Attachment Bulletin # 170405

Subject:

[Oil Filter](#) Cap, Interference with Generator (GEN) Coolant Pipe

A8L with 4.2L (engine code BFM) 2004 > 2005

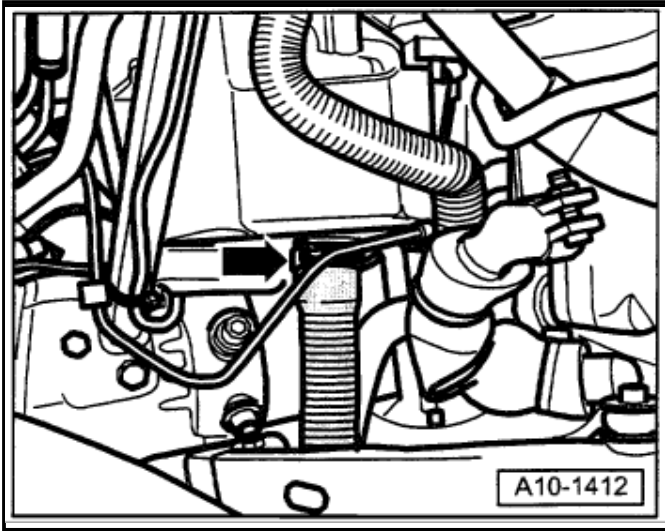
- During engine oil change service, Technician may find that the generator coolant return pipe -arrow- may interfere with removal or installation of the [oil filter](#) cap.

May be caused by an incorrect coolant pipe tolerance allowing the pipe to slightly overlap the [oil filter](#) cap.

Pipe with additional clearance installed beginning with VIN: 4E\_5N005555.

Vehicles should only be retrofitted if [oil filter](#) cap cannot be installed easily.

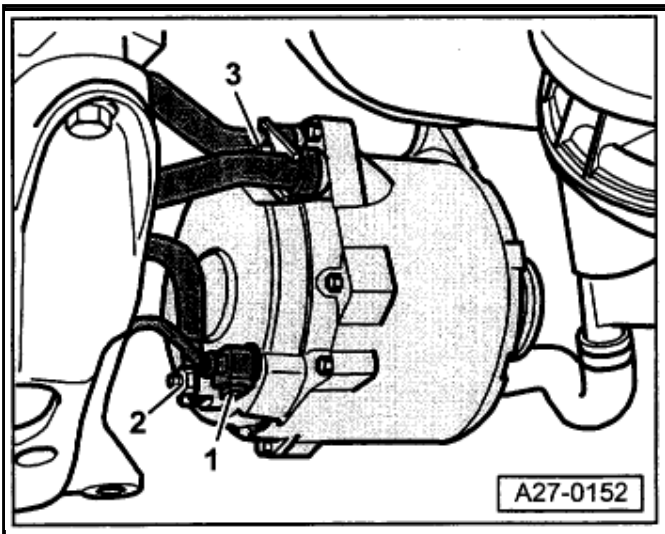
- Remove bolt -1- and mounting plate -2- from the top generator coolant pipe connection.

- Remove bolt -3- and securing plate beneath.

- Replace generator coolant return pipe Part No.: 077 117 412R (includes new seals).
